12	015 / 120 / 31813	S4/GTP/AP/TRANSCO/120KV-SMI/31/POR/002	0	-		
<p>1) Minimum 300mm plinth shall be maintained for CT/PT/CVT/Isolators in the substation during foundation works to ensure safe live to ground clearances as per IE rules.</p> <p>2) Since the supply of terminal connectors is not in the scope of manufacturer as mentioned in the drawings, the EPC contractors shall be instructed to supply the same in line with CT/PT/CVT/Isolators requirement and compatibility.</p>						
<p>Chief Engineer Projects</p>						
CUSTOMER		TRANSMISSION CORPORATION OF ANDHRA PRADESH			TITLE: DRAWING COVER SHEET WITH REVISION STATUS	
3		THIRD ANGLE PROJECTION	INITIALS	NAME	CG Power and Industrial Solutions Limited	
2		SCALE: NTS	DRN	NNJ	LOG-THING ARRESTER DIVISION, AMBAD, NASK	
1		ALL DIM. UNLESS OTHERWISE SPECIFIED.	CHD	PSB	DRG NO. : 001 / 120 / 31813	
NO	REVISION	DATE	APPD	NJ	REV 0	
4		DATE: 11.05.2022			CGI.W.D.: APTRANSCO_STD_120KV_SH.1 OF 1

CUSTOMER	TRANSMISSION CORPORATION OF ANDHRA PRADESH				
3	THIRD ANGLE PROJECTION	SCALE: NTS	INITIALS	NAME	TITLE: GENERAL ARRANGEMENT FOR 120KV, 10KA, SM-TYPE PORCELAIN HOUSED SURGE ARRESTER(Cs-16C)
2	ALL DIM. UNLESS OTHERWISE SPECIFIED.	DRN	NINJ		<p>CG P

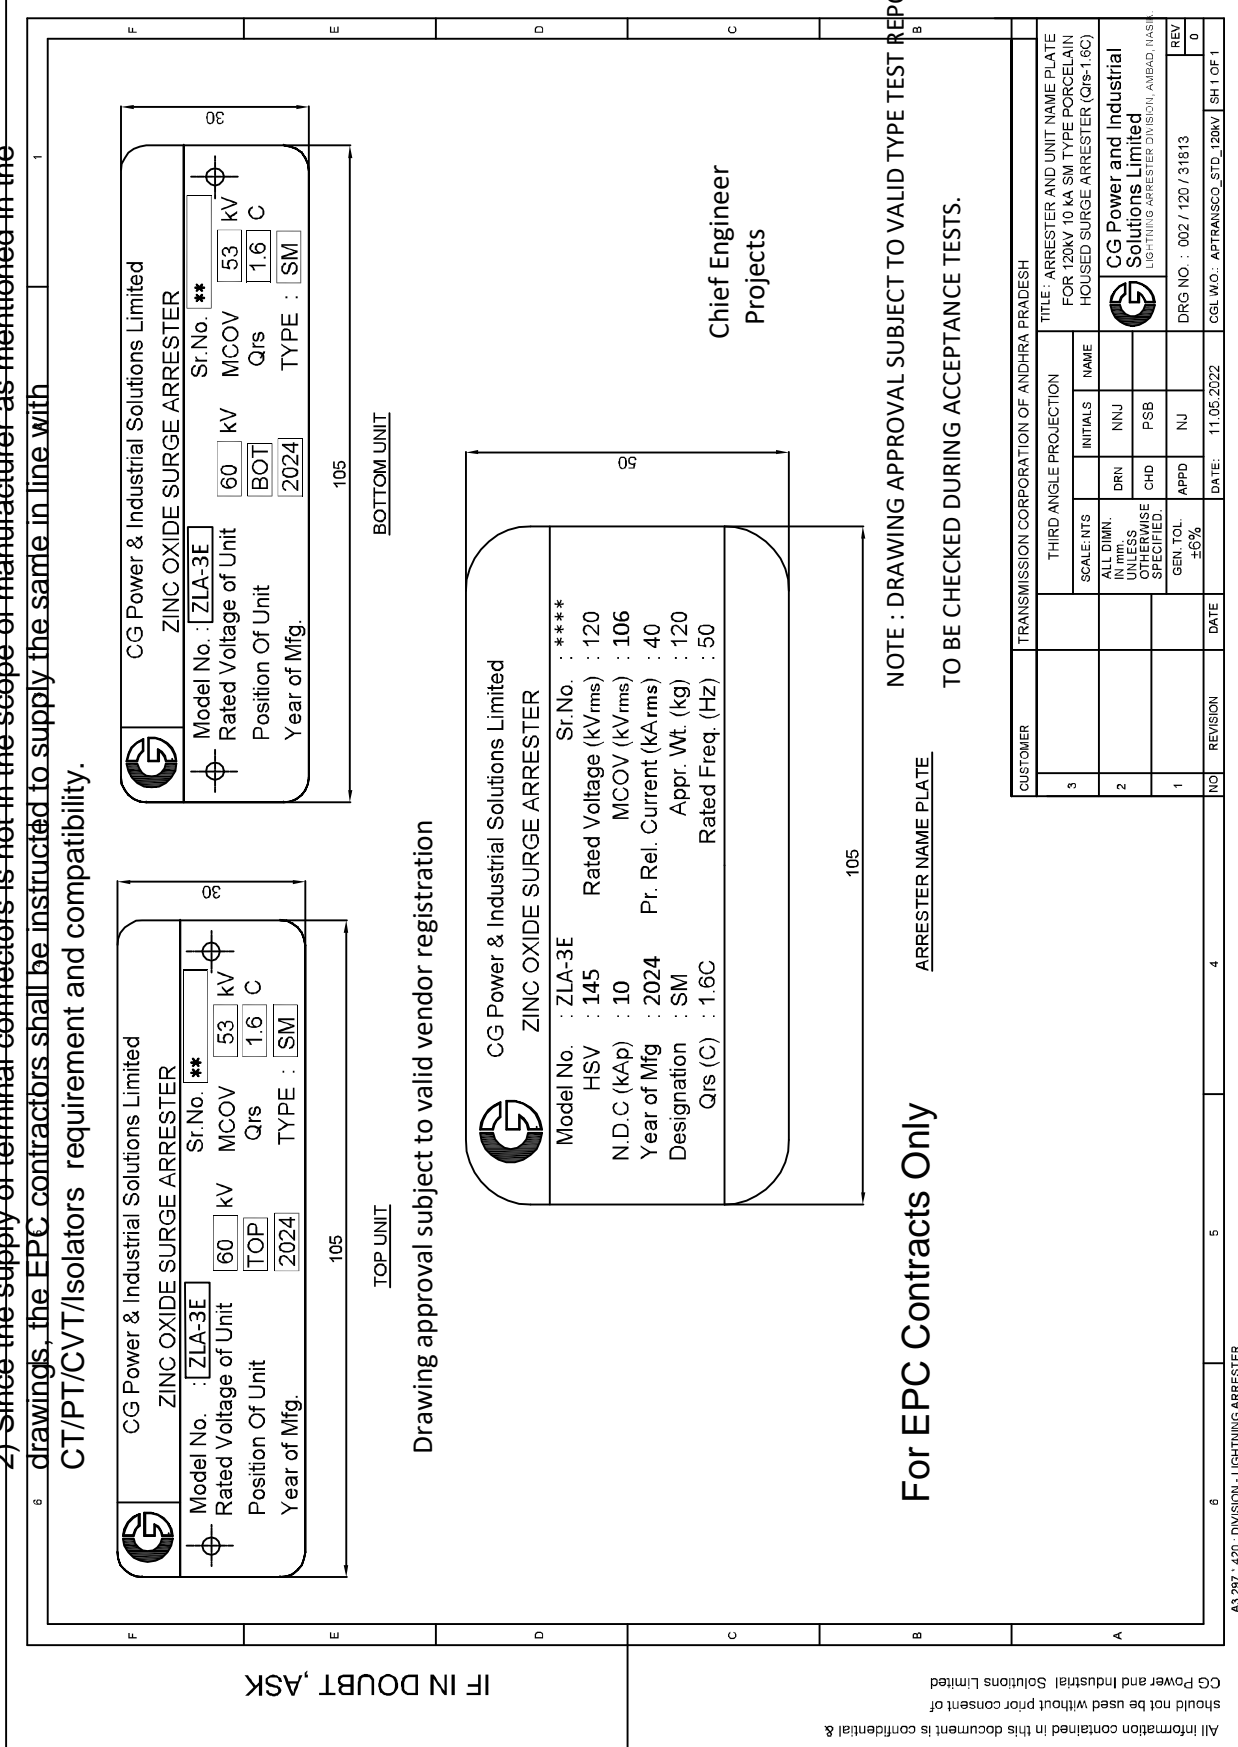
1) Minimum 300mm plinth shall be maintained for CT/PT/CVT/Isolators in the substation during foundation works to ensure safe live to ground clearances as per IE rules.

2) Since the supply of terminal connectors is not in the scope of manufacturer as mentioned in the drawings, the EPC contractors shall be instructed to supply the same in line with CT/PT/CVT/Isolators requirement and compatibility.

Title: GENERAL ARRANGEMENT DRAWING OF SURGE COUNTER

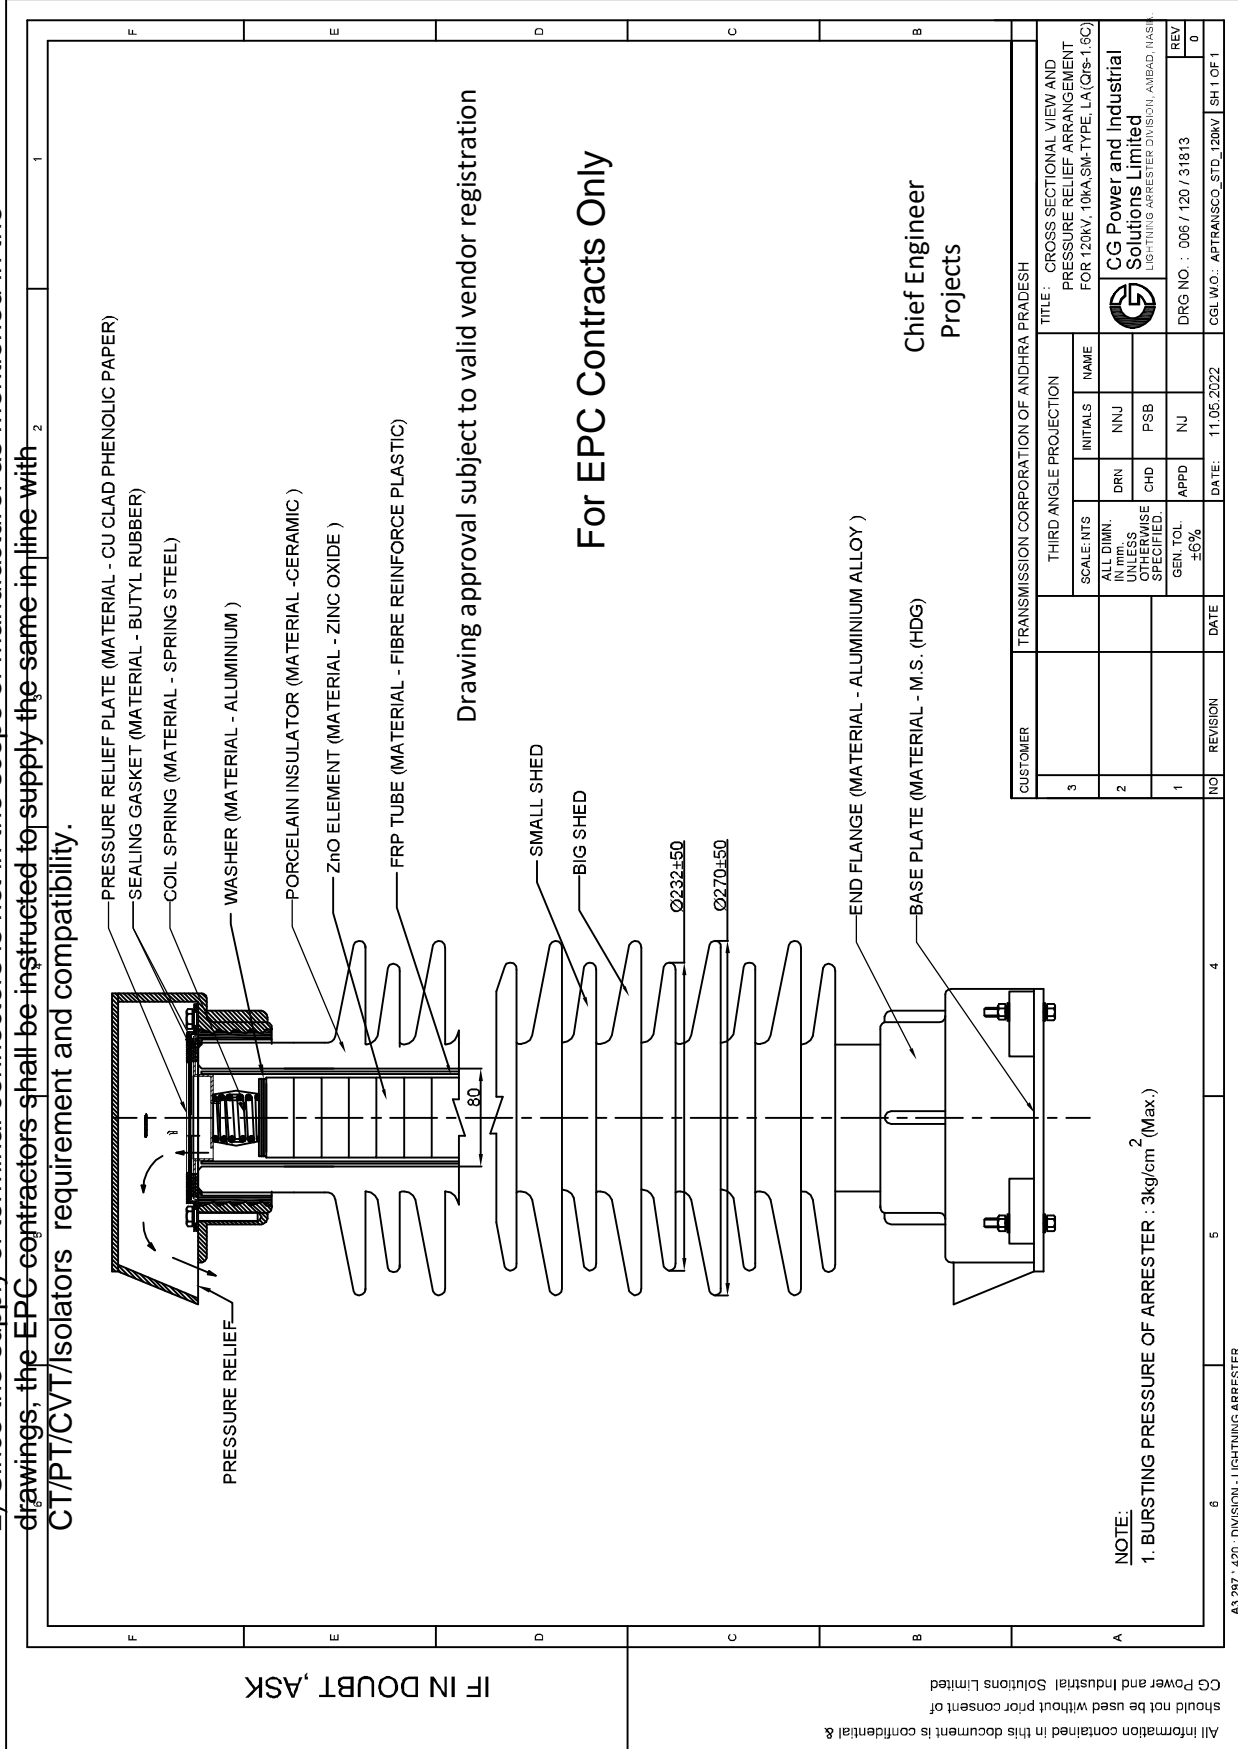
1) Minimum 300mm plinth shall be maintained for CT/PT/CVT/Isolators in the substation during foundation works to ensure safe live to ground clearances as per IE rules.

2) Since the supply of terminal connectors is not in the scope of manufacturer as mentioned in the drawings, the EPC contractors shall be instructed to supply the same in line with CT/PT/CVT/Isolators requirement and compatibility.

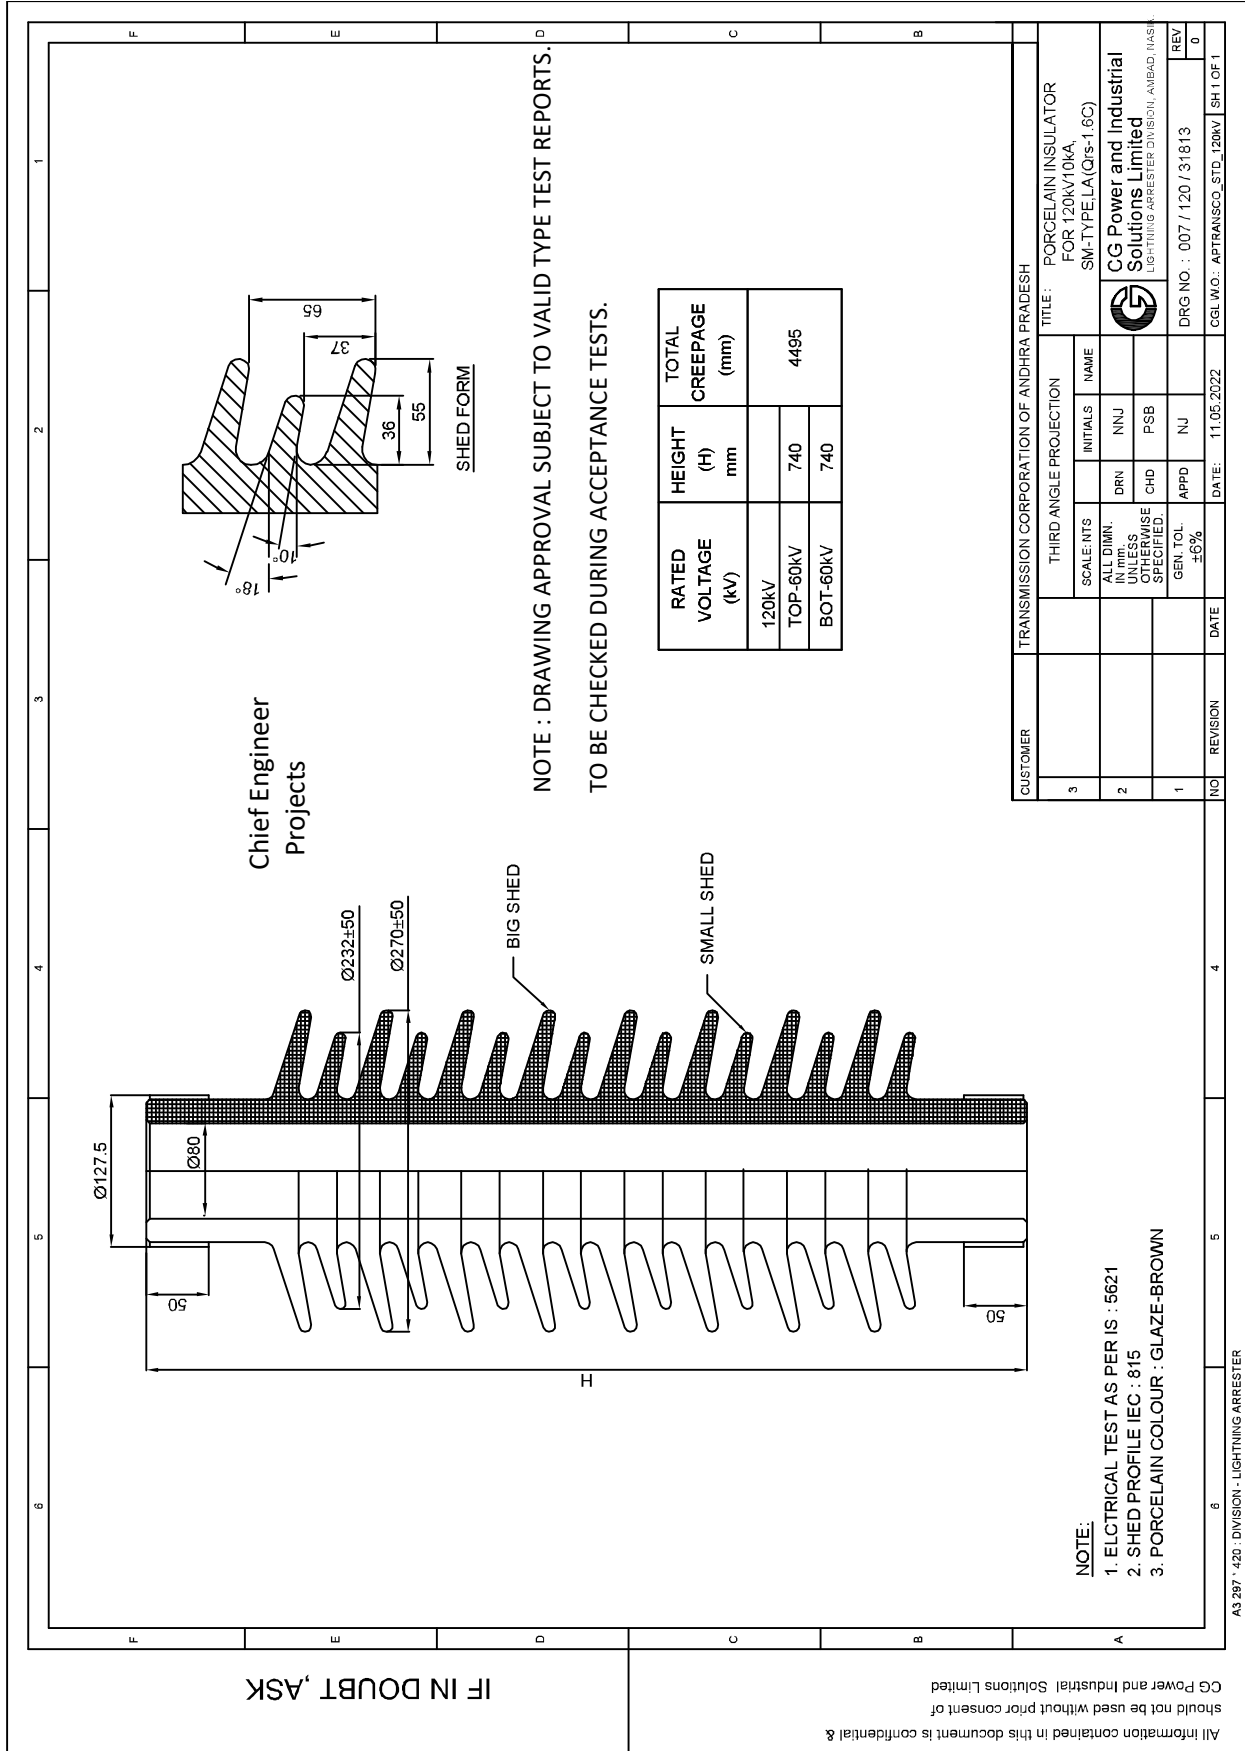
1) Minimum 300mm plinth shall be maintained for CT/PT/CVT/Isolators in the substation during foundation works to ensure safe live to ground clearances as per IE rules.

2) Since the supply of terminal connectors is not in the scope of manufacturer as mentioned in the drawings, the EPC contractors shall be instructed to supply the same in-line with CT/PT/CVT/Isolators requirement and compatibility.

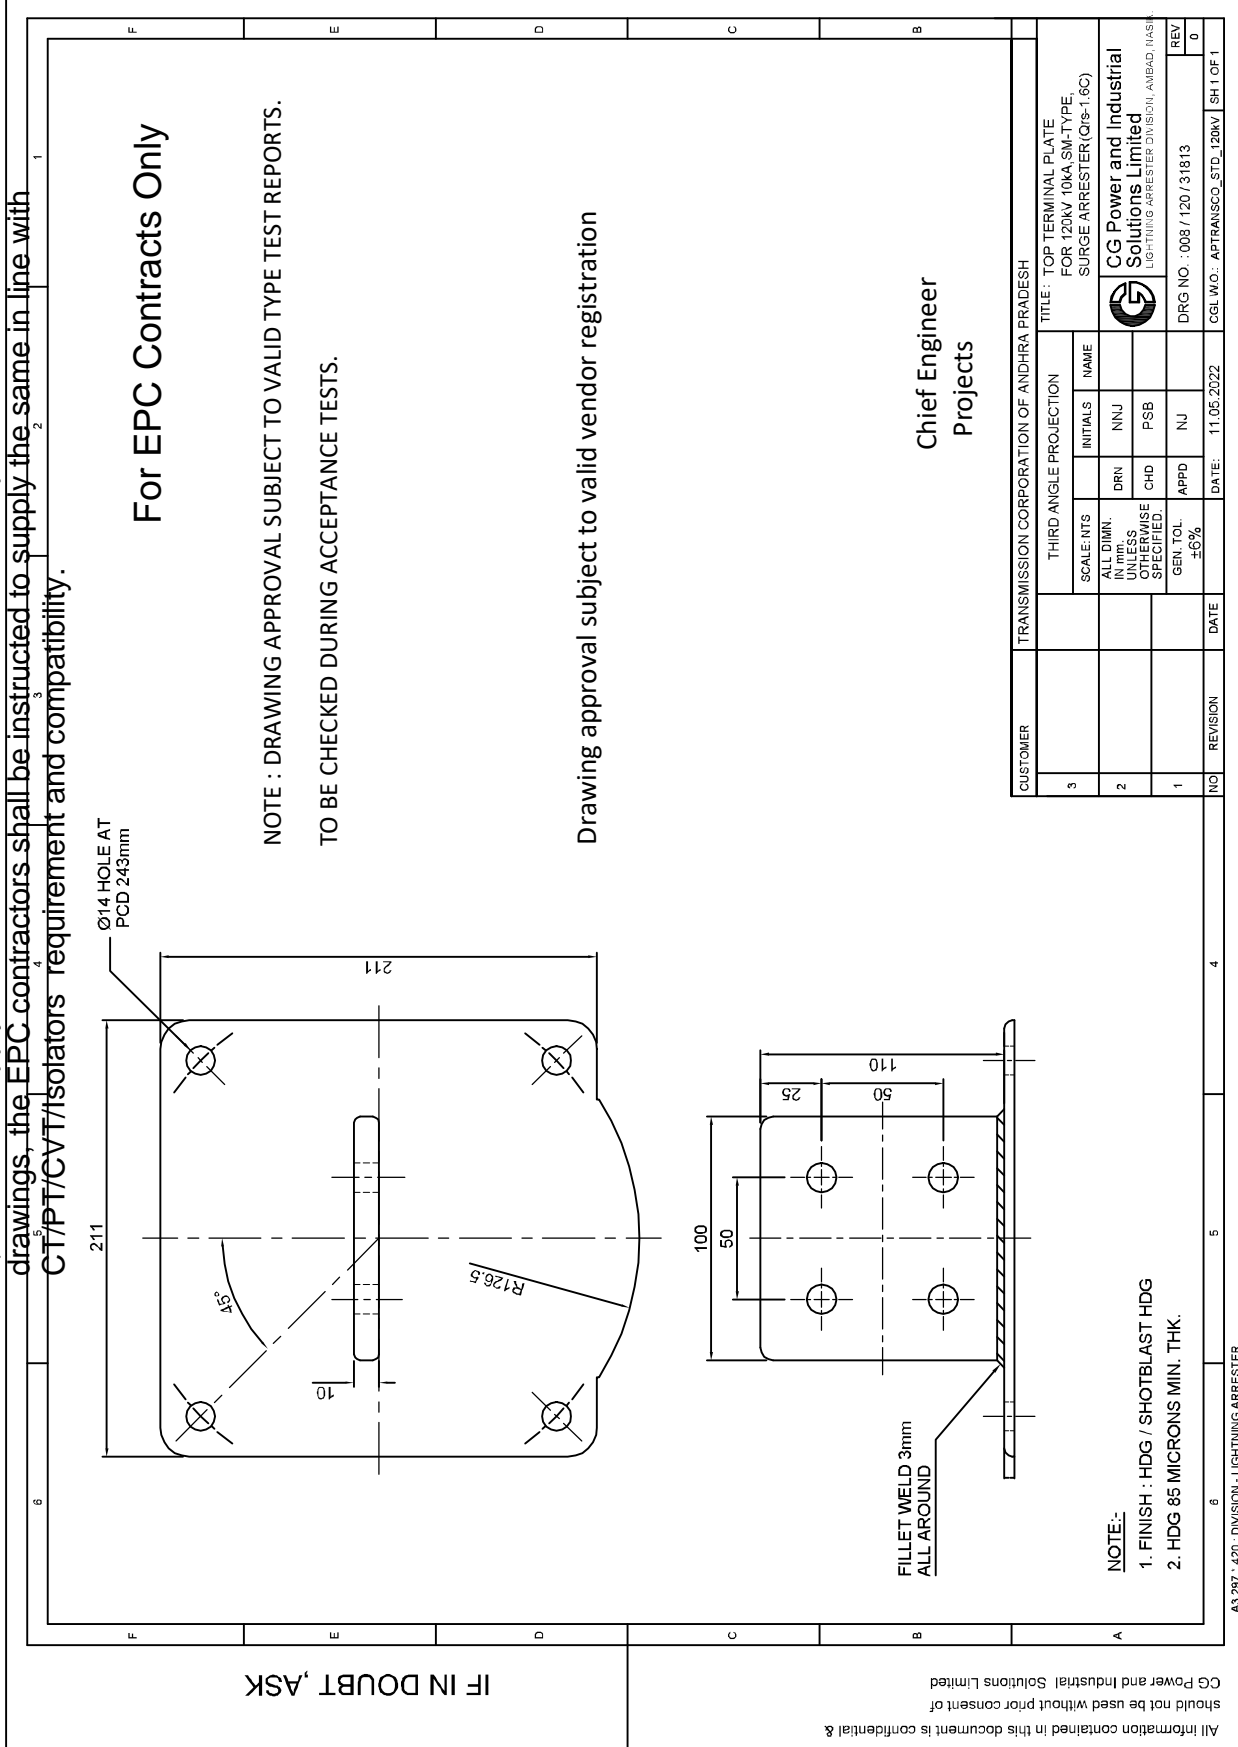
- 1) Minimum 300mm plinth shall be maintained for CT/PT/CVT/Isolators in the substation during foundation works to ensure safe live to ground clearances as per IE rules.
- 2) Since the supply of terminal connectors is not in the scope of manufacturer as mentioned in the drawings, the EPC contractors shall be instructed to supply the same in line with CT/PT/CVT/Isolators requirement and compatibility.

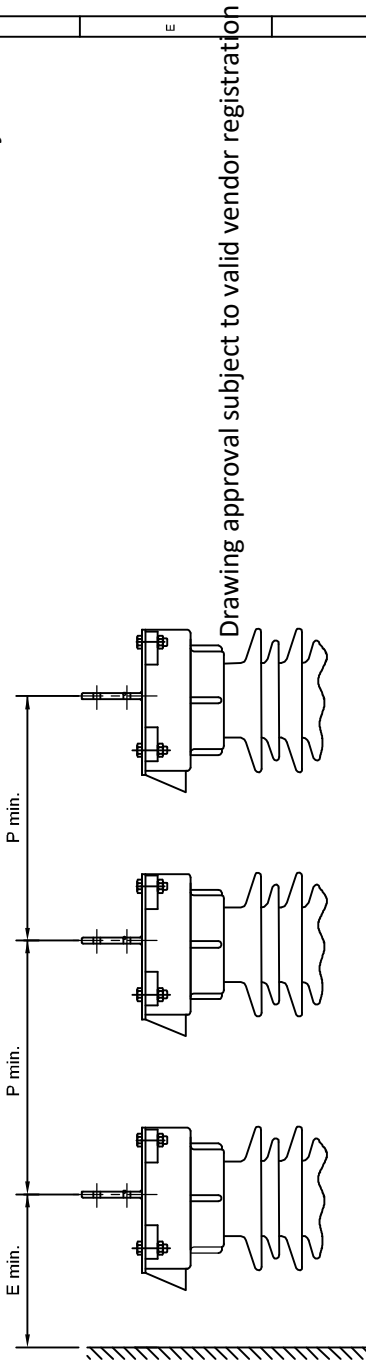
1) Minimum 300mm plinth shall be maintained for CT/PT/CVT/Isolators in the substation during foundation works to ensure safe live to ground clearances as per IE rules.

2) ~~Since the supply of terminal connectors is not in the scope of manufacturer as mentioned in the drawings, the EPC contractors shall be instructed to supply the same in line with CT/PT/CVT/Isolators requirement and compatibility.~~

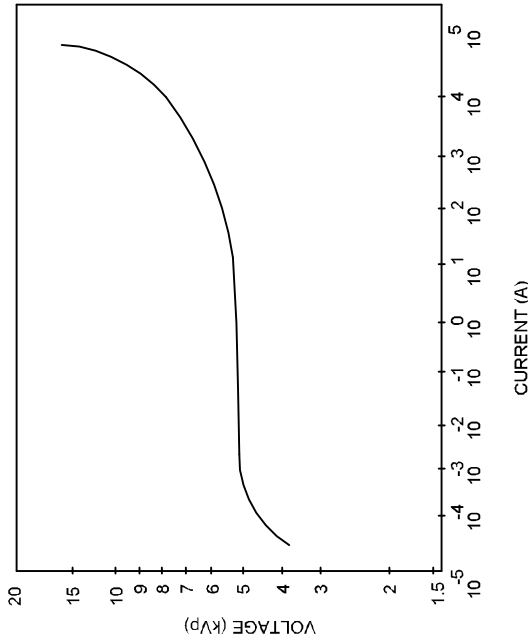
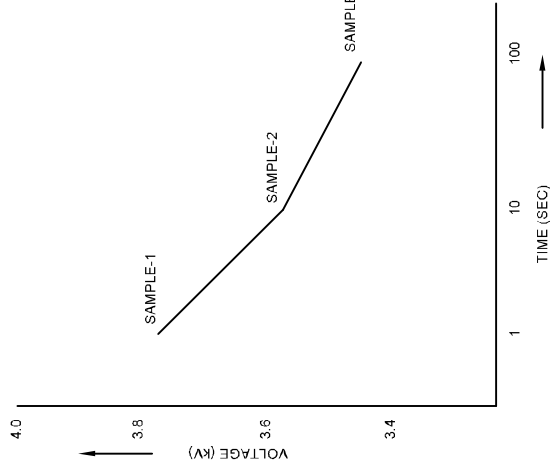
1) Minimum 300mm plinth shall be maintained for CT/PT/CVT/Isolators in the substation during foundation works to ensure safe live to ground clearances as per IE rules.

2) Since the supply of terminal connectors is not in the scope of manufacturer as mentioned in the drawings, the EPC contractors shall be instructed to supply the same in line with CT/PT/CVT/Isolators requirement and compatibility.
NOTE : DRAWING APPROVAL SUBJECT TO VALID TYPE TEST REPORTS.

TRANSMISSION CORPORATION OF ANDHRA PRADESH		ZnO ELEMENT FOR CL-3 SM TYPE SURGE ARRESTER	
CG Power and Industrial Solutions Limited		LOG-THING ARRESTER DIVISION, AMBAAD (NASHIK)	
DRG NO. : 011 / 120 / 31813		REV 0	
CGI.W.D. : APTRANSCO STD_120KV		SH.1 OF 1

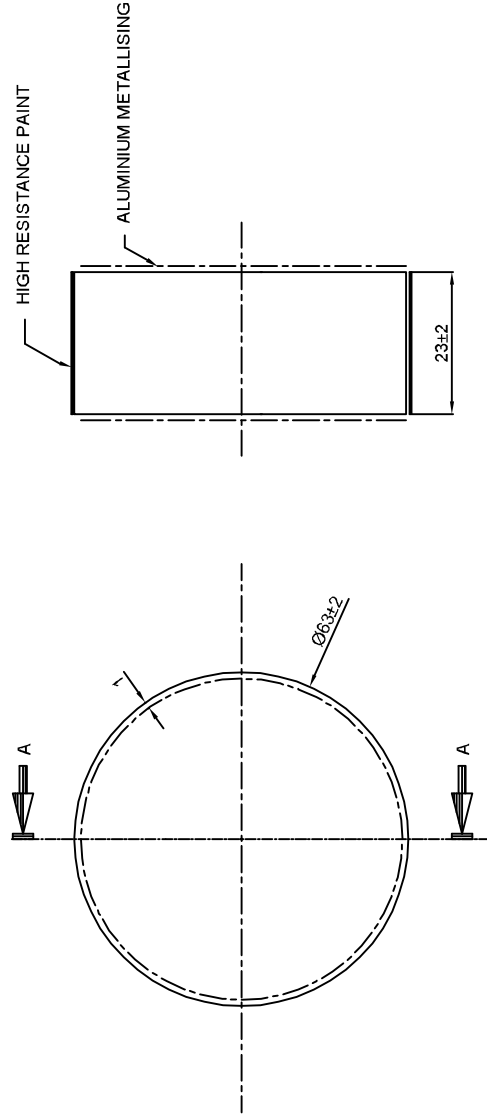
1) Minimum 300mm plinth shall be maintained for CT/PT/CVT/Isolators in the substation during foundation works to ensure safe live to ground clearances as per IE rules.

2) Since the supply of terminal connectors is not in the scope of manufacturer as mentioned in the drawings, the EPC contractors shall be instructed to supply the same in line with CT/PT/CVT/Isolators requirement and compatibility.
